CLARKSON SUBDIVISION

APPLICATION NUMBER 13 DATE April 7, 2005

REQUEST Subdivision

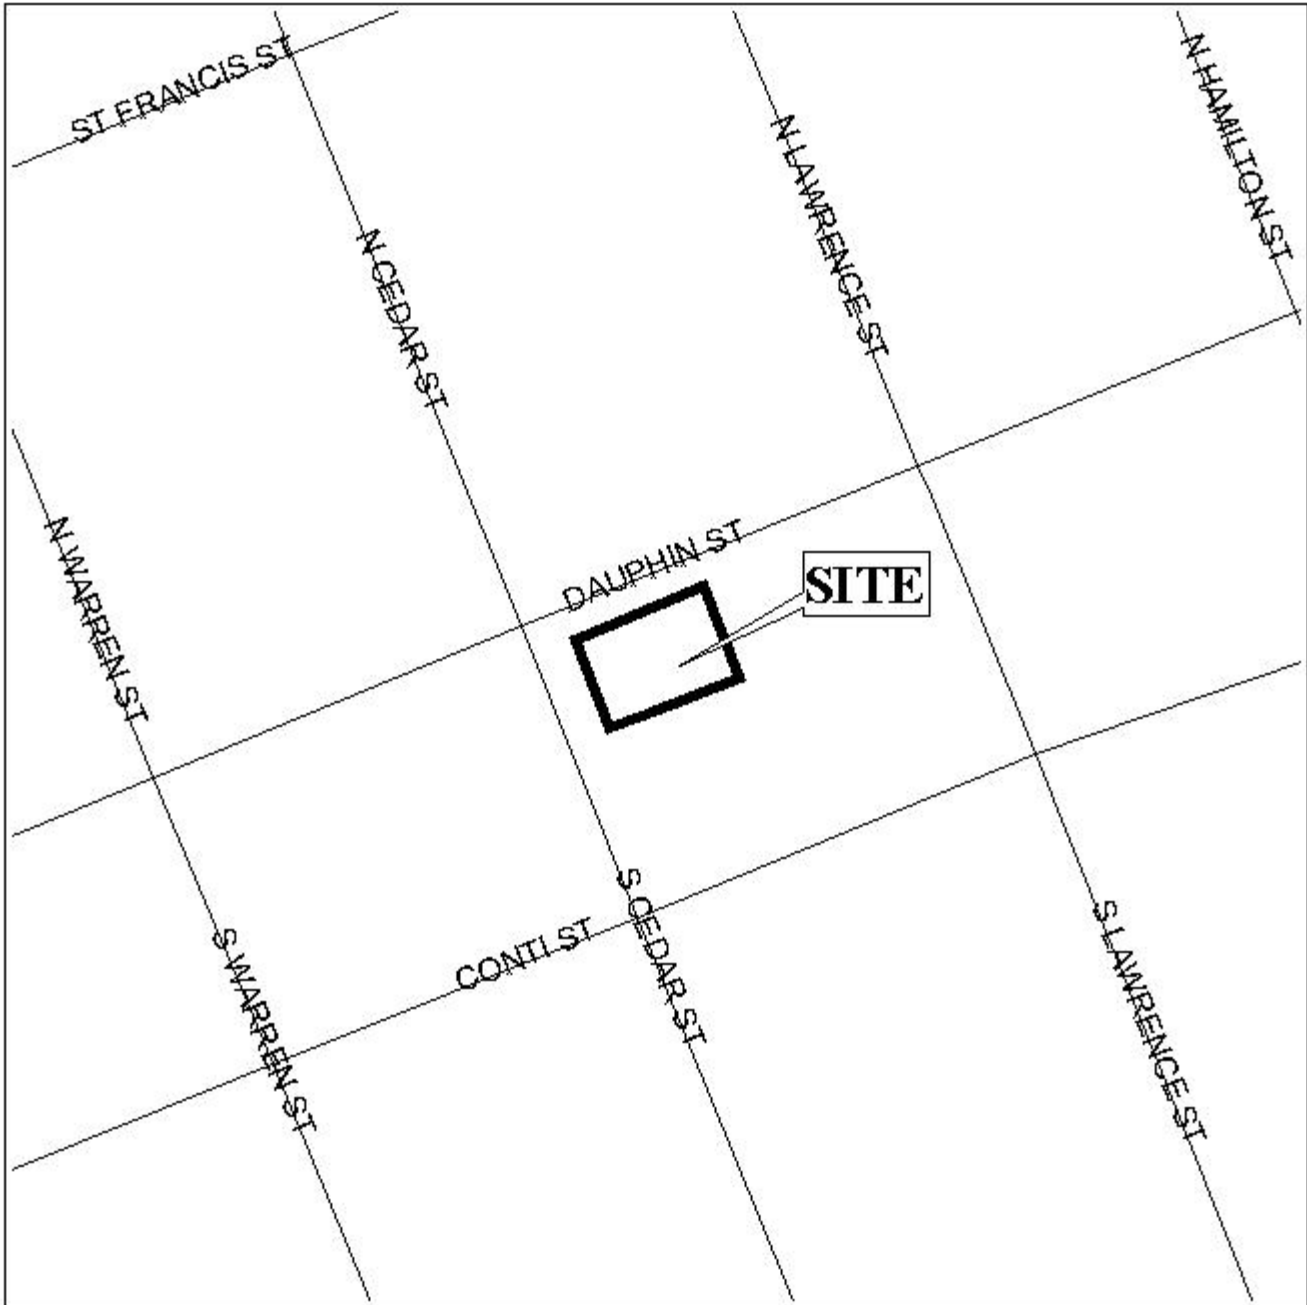
The purpose of this application is to create a four-lot subdivision from two metes and bounds parcels for a townhome development. The site is located within the Central Business District and is zoned B-4, General Business. Although the Subdivision Regulations require a minimum lot size with 7,200 square feet, B-4 zoning does not have a minimum lot size requirement. The proposed lots are compatible with the surrounding development, thus it would be appropriate to waive Section V.D.2. of the Subdivision Regulations.

There is no radius at the corner of Lot 1; however the site reflects the prevailing treatment of property lines and curbs in the Central Business District area, thus a waiver of Section V.D.6. (curb radii at corners at least 10-feet) should be required.

While the Subdivision Regulations call for each lot to have a 25-foot building setback line, B-4 zoning does not have a minimum front yard setback. Additionally, as reflected on the Vicinity Map, the surrounding buildings are built up to the front property line, thus a waiver of Section V.D.9. would be appropriate.

With a waiver of Sections V.D.2., V.D.6. and V.D.9., the plat will meet the minimum requirements of the Subdivision Regulations and is recommended for Tentative Approval subject to the following conditions: 1) the dedication of a 25-foot radius at the corner of Dauphin Street and Cedar Street; and 2) the placement of the 25-foot minimum setback lines on the final plat.
